Submission:

Draft Kyneton Airfield Masterplan 6 June, 2016

1 ASSOCIATION'S RESPONSE TO THE KYNETON AIRFIELD MASTERPLAN

Figure 1 Kyneton town residential areas (purple) relative to the Kyneton airfield (red). The green area is the existing Airport Environs Overlay applied to the airfield.

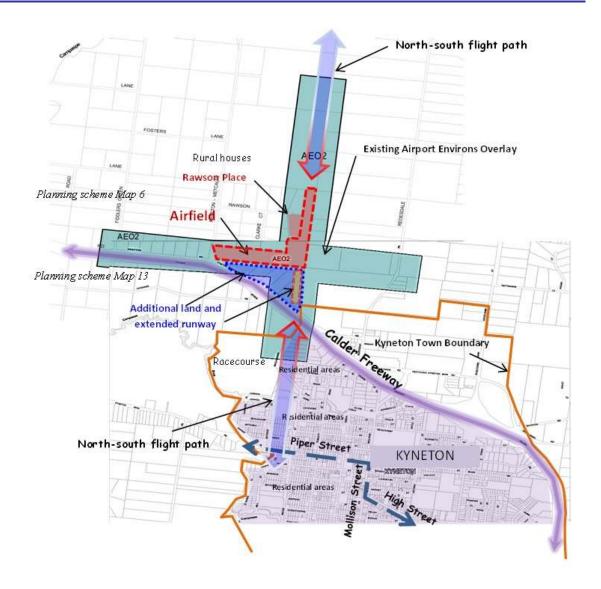
Kyneton airfield is a mere 19.7ha in size (197,000 sqm, page 5 Masterplan). It has no physical buffer areas.

The airfield is also only 600 metres from Kyneton's township residential areas, and planes presently (and will continue to) fly over the town proper, increasing safety and noise concerns/objections. The proposed runway extension will bring the runway to within 300 metres of town residential areas (separated by the Calder Freeway). The Masterplan fails to identify this proximity and instead misleadingly says the airfield is "2 km from Kyneton".
